Date: March 13, 2007

From: George Penokie (IBM)

Subject: SAS-2: Transport level read fixes

Figure 1 — Representation of transport layer (i.e., ST\_ITS6) read data operation

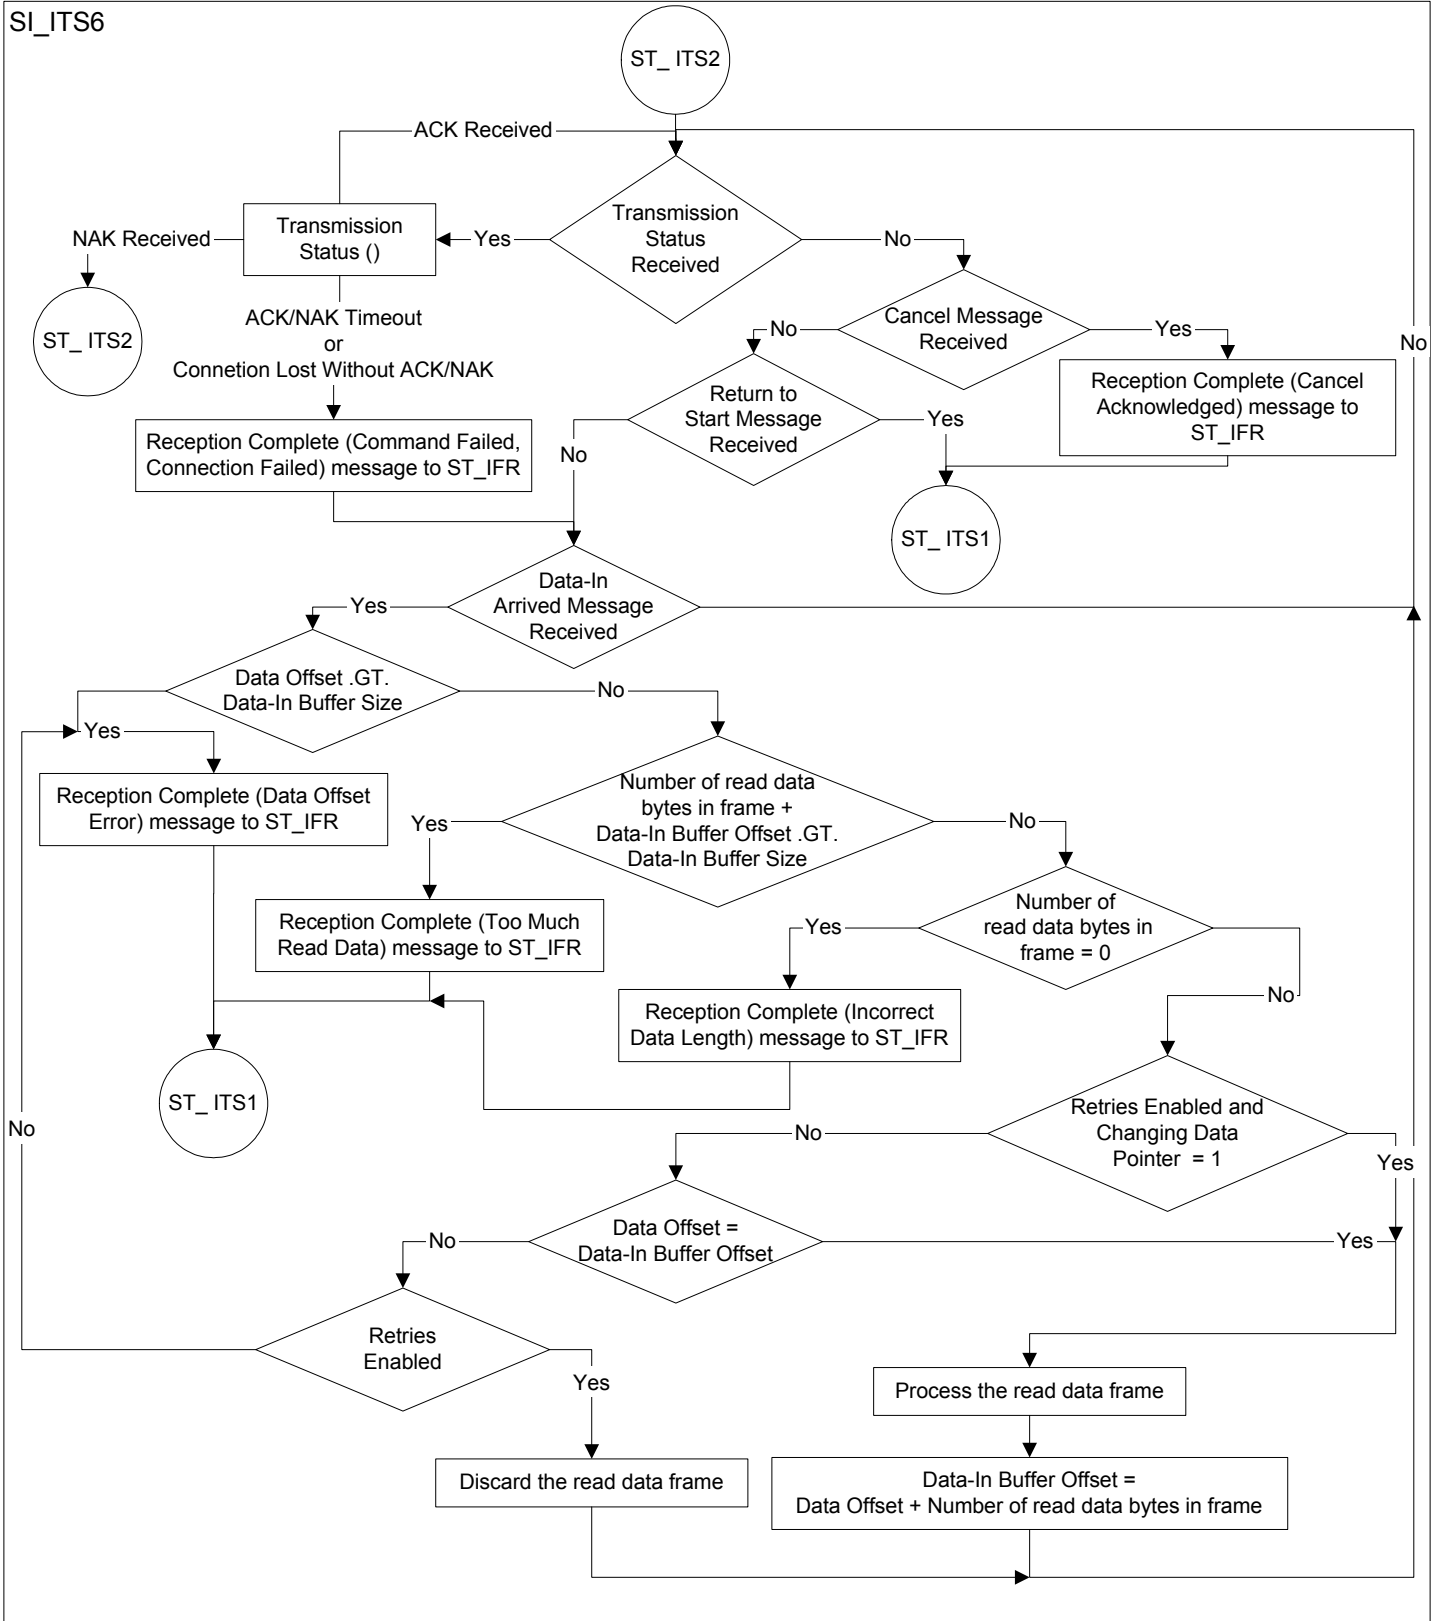
The flow chart also needs to be adjusted as there are some errors in it (see figure 1).
